# 1966 Corvette: Reliability Data Center Letter: Poor Release and High Pedal Effort - 1966 327 CID Corvette Engines

Your Reliability Data Center  
Flint V-8 Engine Plant

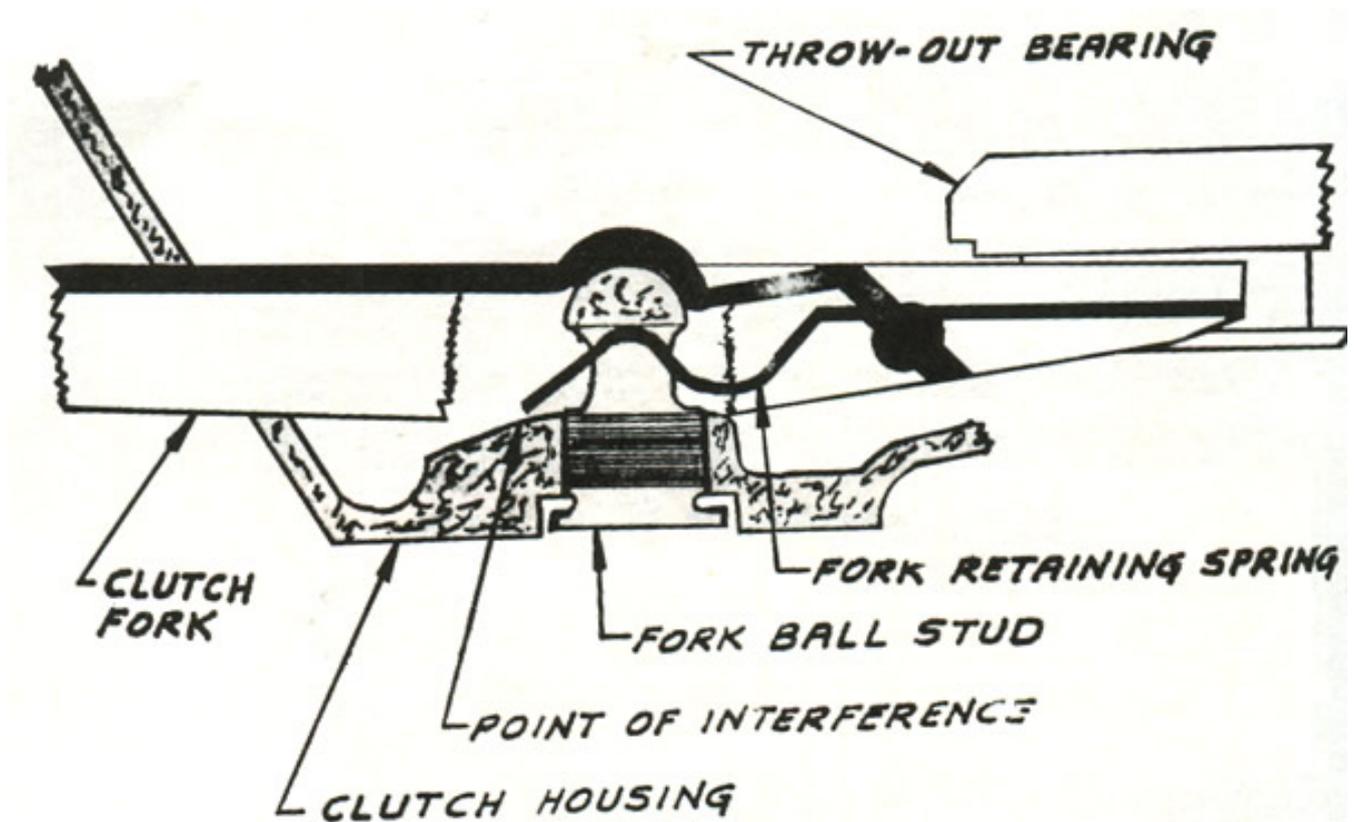
Recent investigation of poor release of clutch, high pedal effort and disc wear has isolated the condition to the clutch fork retainer tangs interfering with the clutch housing boss provided for the ball stud which causes a reduction in fork travel.

The above condition is caused by a short ball stud Part No. 3887159 which was used on 1966 327 CID Corvette engines until 4-4-66. At that time the past design ball stud part No. 3729000 was again installed and is currently being used.

In the event a complaint of high pedal effort or poor release is encountered the unit should be inspected for the above mentioned condition. (see attached illustration).

The correct ball stud Part No. 372900 has an overall length of 1 1/2 inches, the shorter stud, Part No. 3887159 is approximately 1 3/8 inches long.
